Planning Commission MEETING AGENDA

Thursday, September 19, 2024 - 1:00 PM
Council Chambers, Easton Town Office
14 S Harrison Street

**Town of Easton Planning Commission
Draft Decision Summary**

**PLANNING COMMISSION
PUBLIC HEARING
STAFF REPORT**

SHEET NO.:
C-401.01

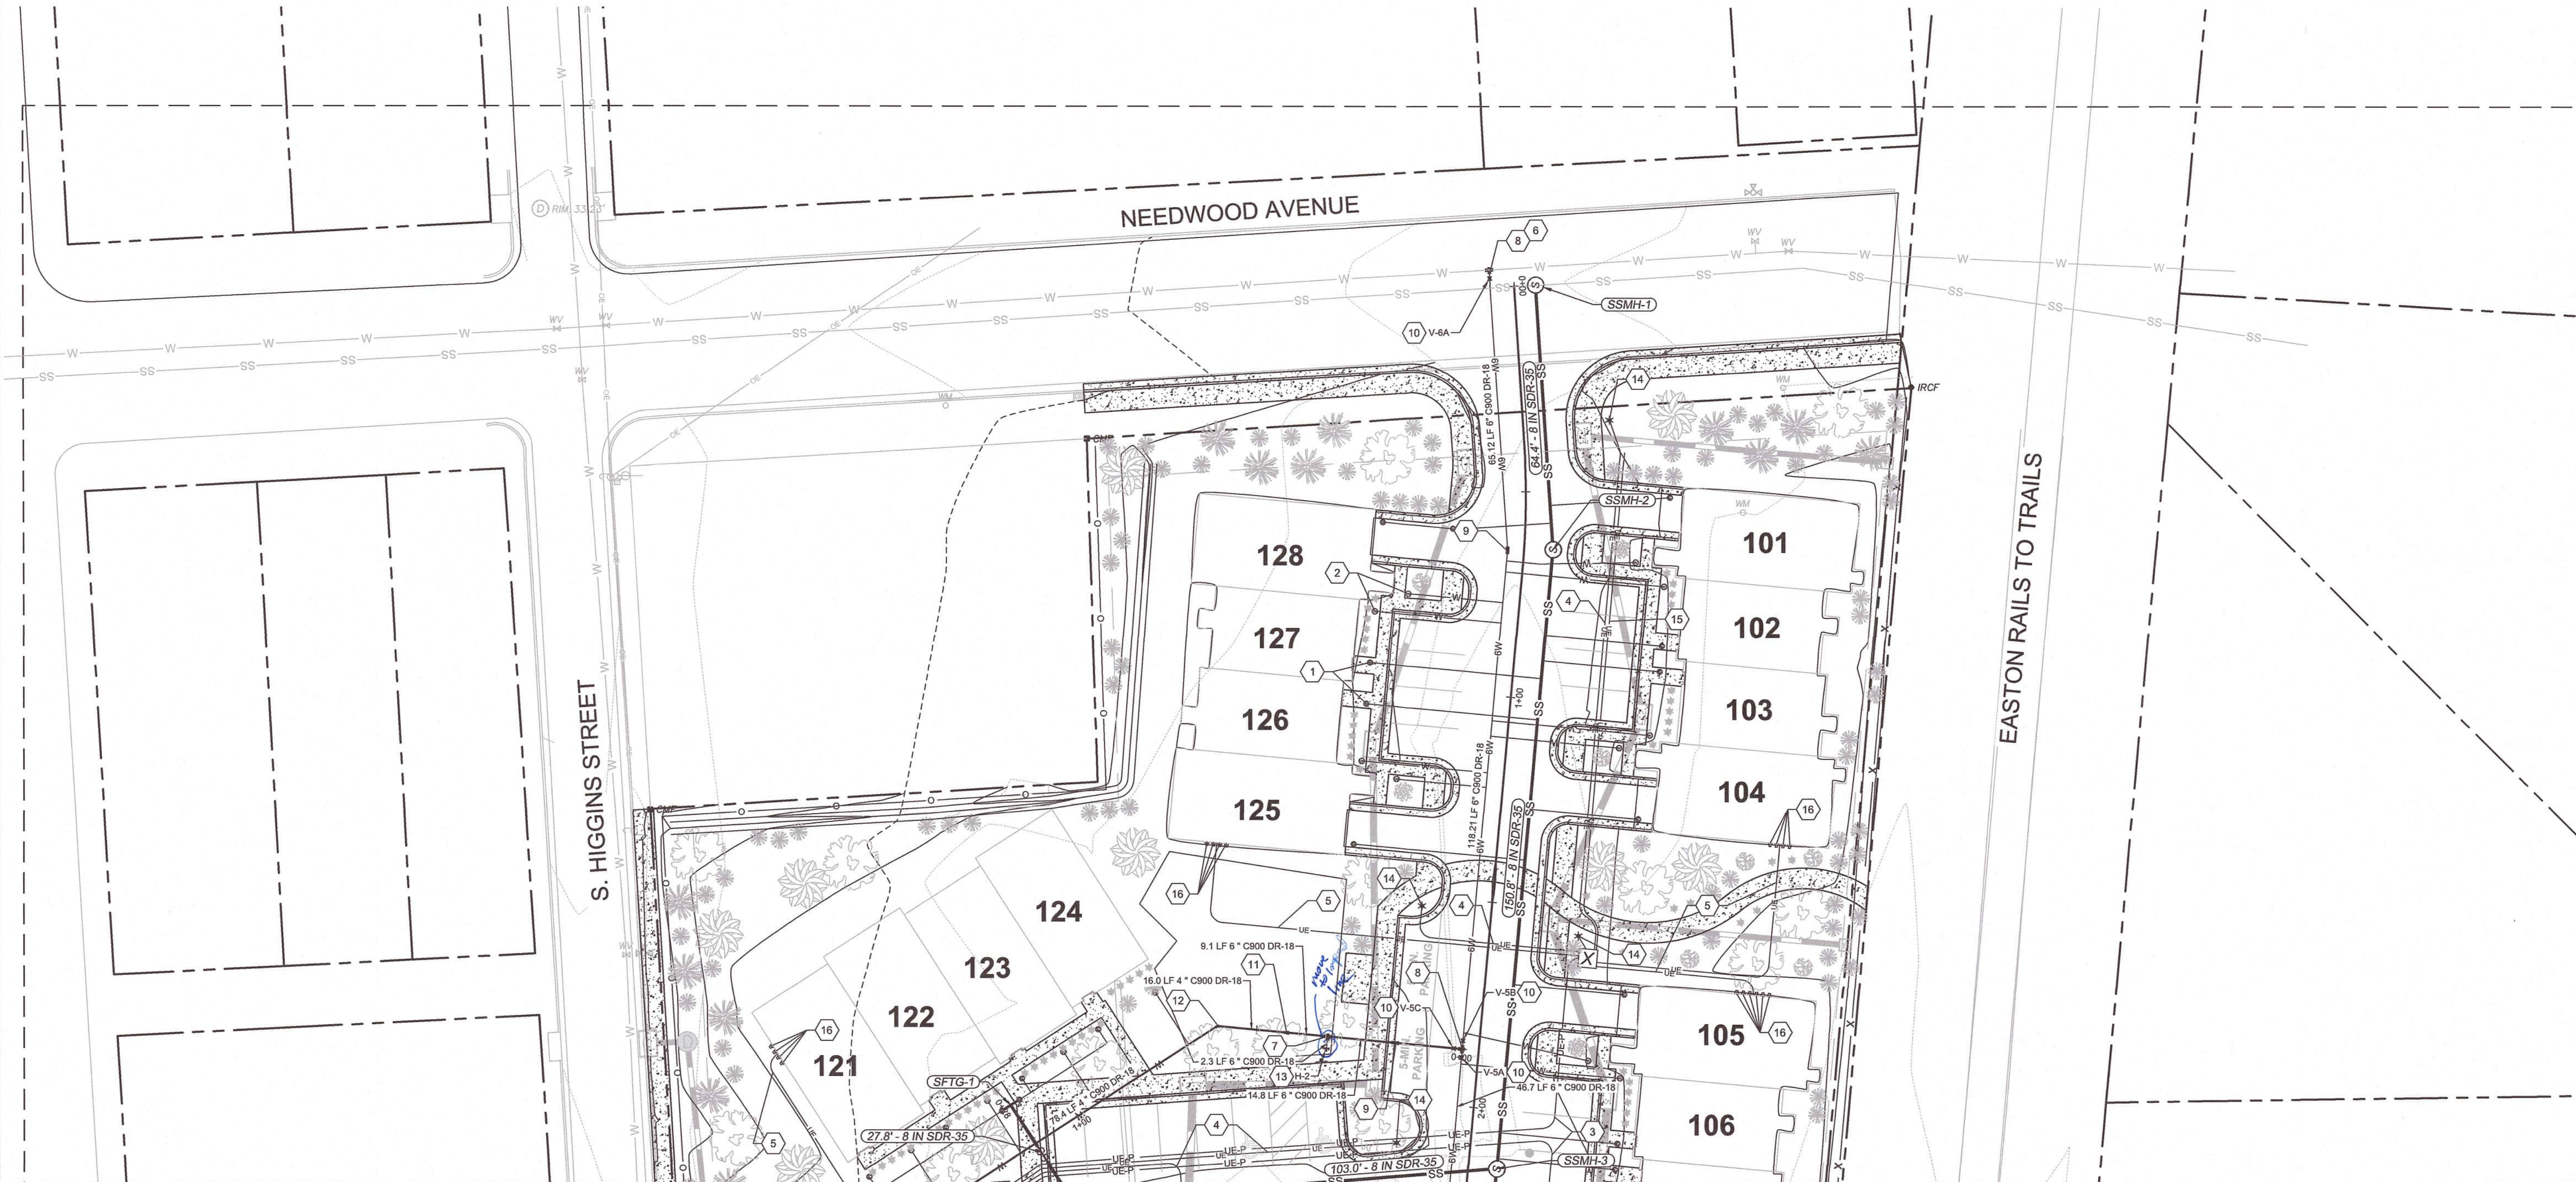
ITEM:	DRAWING / PAGE	COMMENTS:
1	401.02	Will the electric vehicle charging stations be metered by themselves?
2	General	Capital charges required for 28 EDU's in the amount of \$197,400.
3	C-101	Add terminal manhole to sewer on Higgins
4	C-101	Loop watermain to 6" main on Maryland
5	C-101	Move fire hydrant to looped main
6	C-101	Realign water for 121 to 124
7	General	Easements required for utilities
8	General	Install communication conduit with electric
9	C-101	See comments. Contact Easton Utilities for electric design. Meter locations, service size and panel schedule needed for design. Electric design shown on prints no approved.

SHEET NO.: G-100

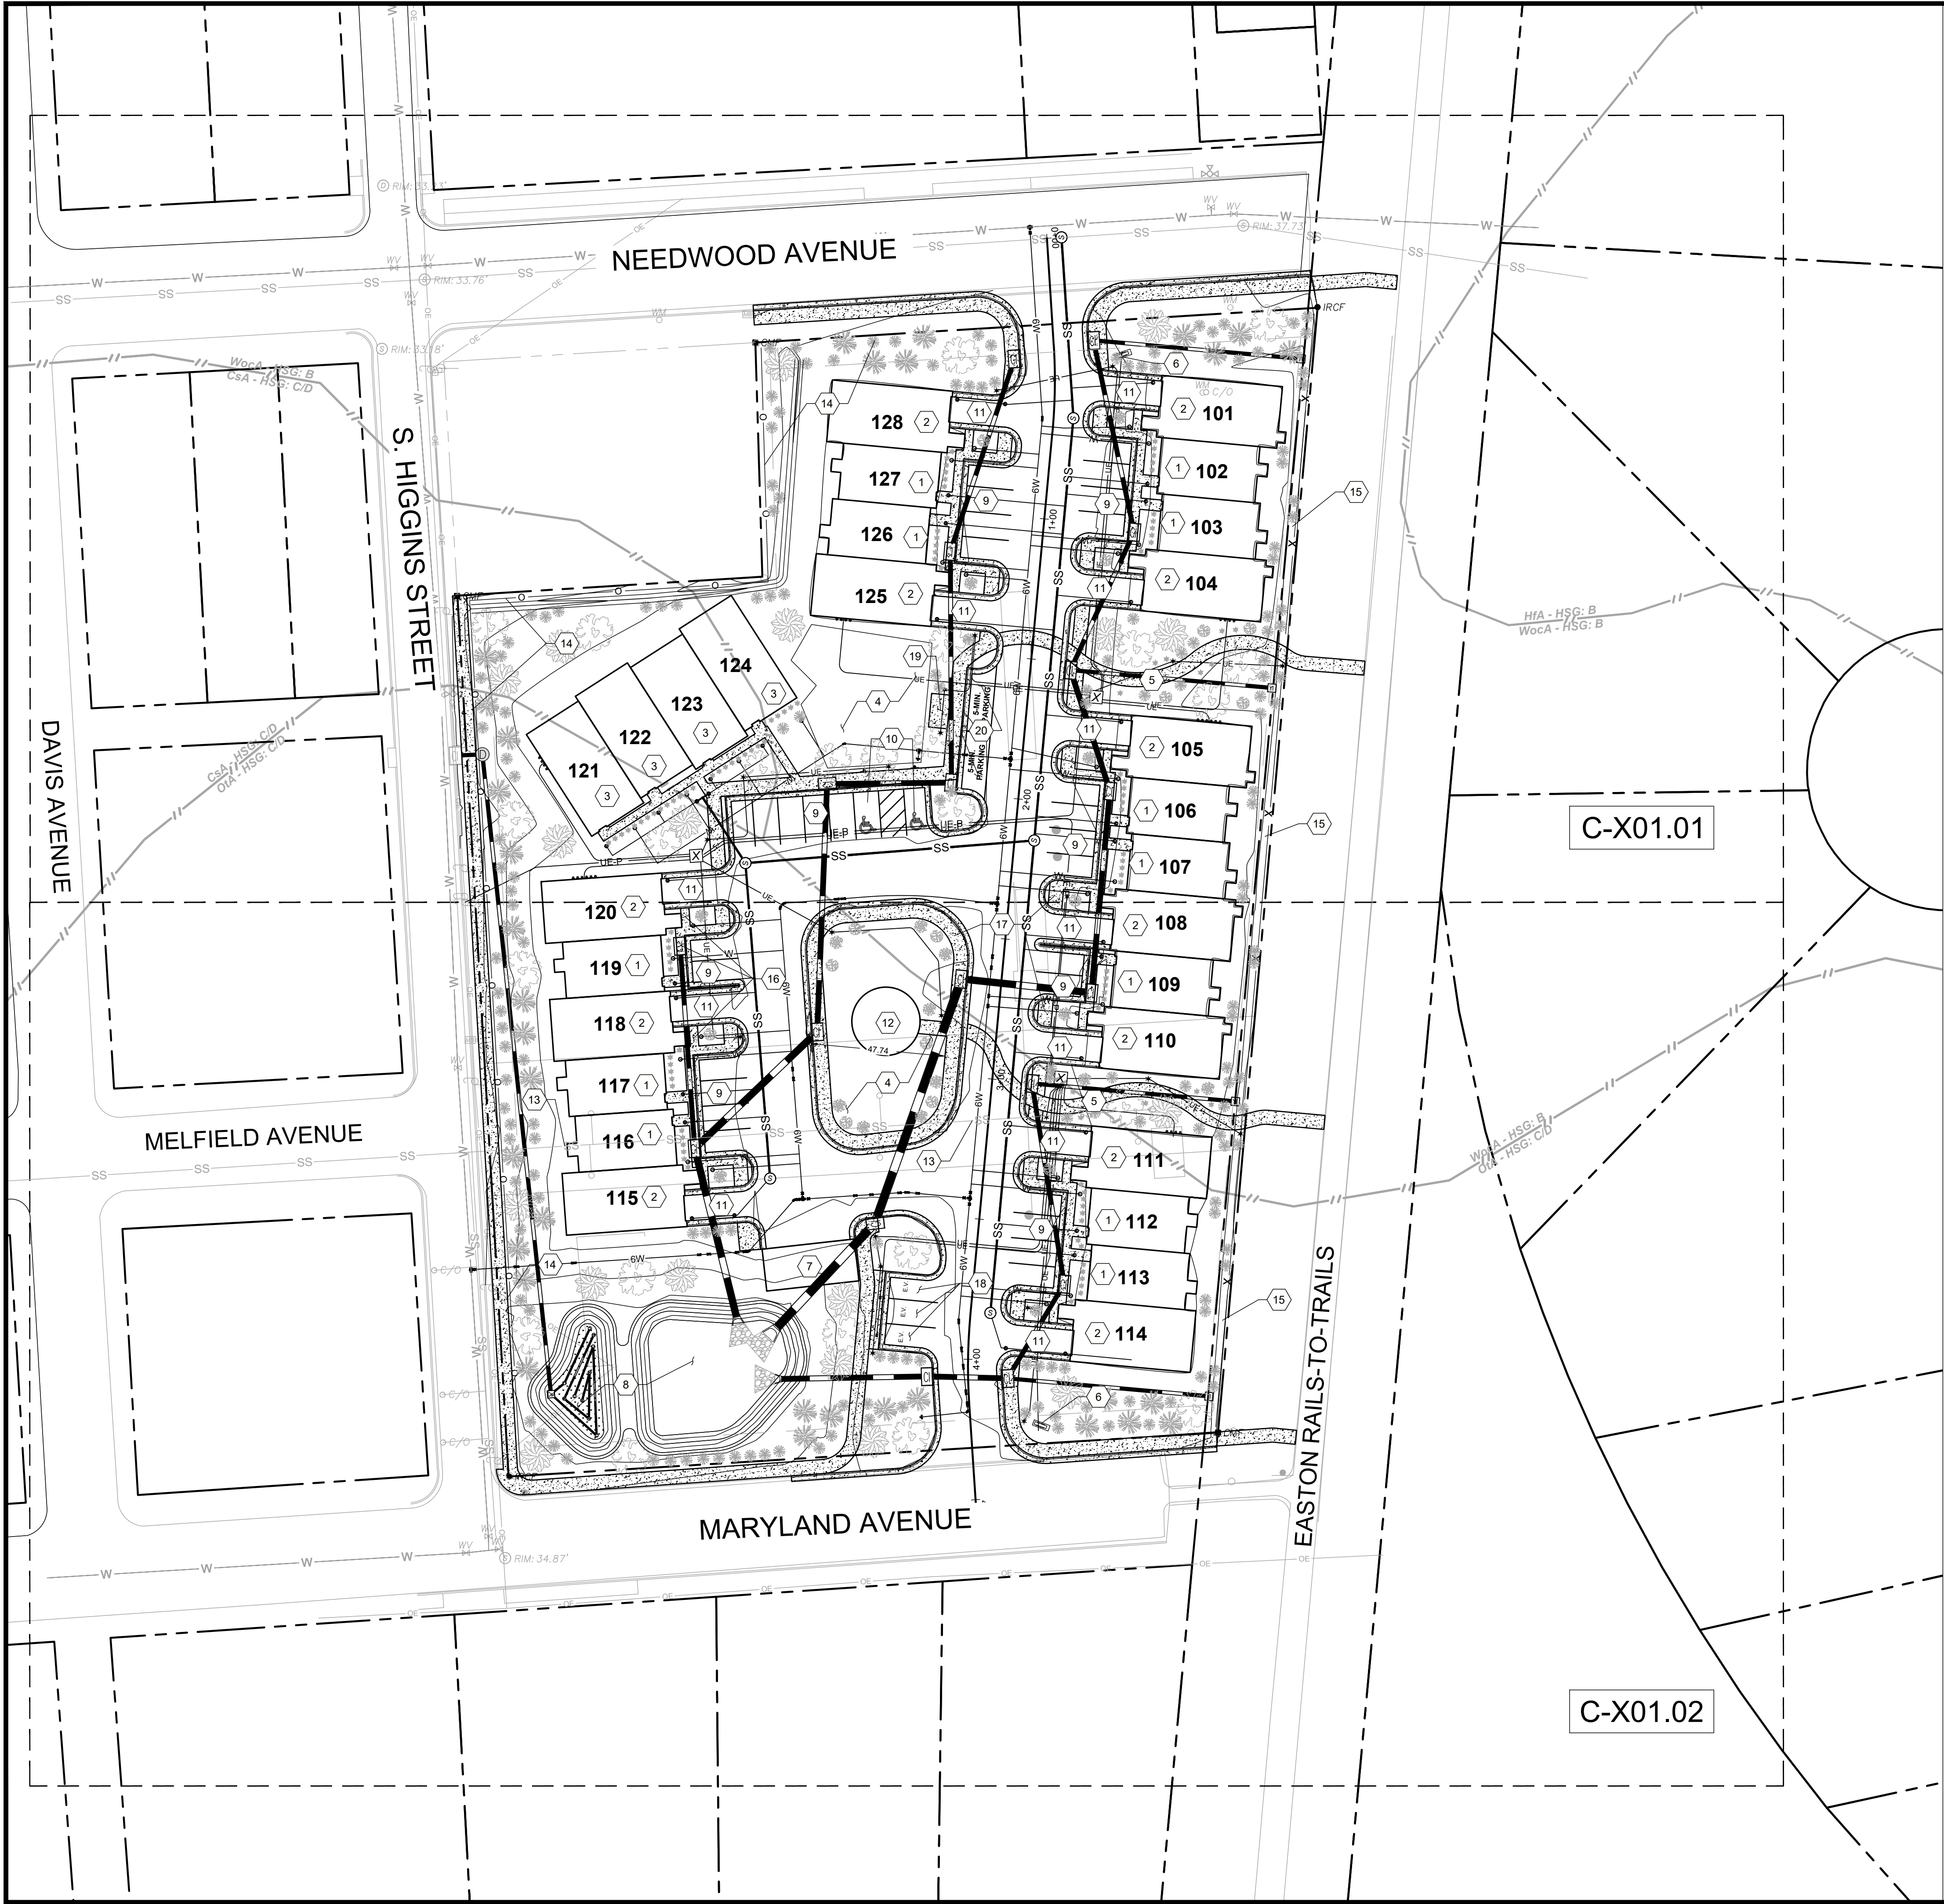
2. Revise the Site Data on sheet G-100 to include all existing Zoning Districts; Business Commercial, PRD Boundary and **PUD Infill Boundary**.
3. Per Appendix B, Sketch Plan Submittal Checklist requires the location of exterior lighting to be shown on plan view.

7. Per § Section 28-501 B(1) through (8) from the Town's Zoning Ordinance, respond to the development requirements and add statements onto sheet G-100.

12. Per § Section 31-3.2 from the Town's Forest Conservation Ordinance #718, state on sheet G-100 exemption "O", *the proposed activity is on a previously developed area covered by impervious surface and is located within the priority funding area.*
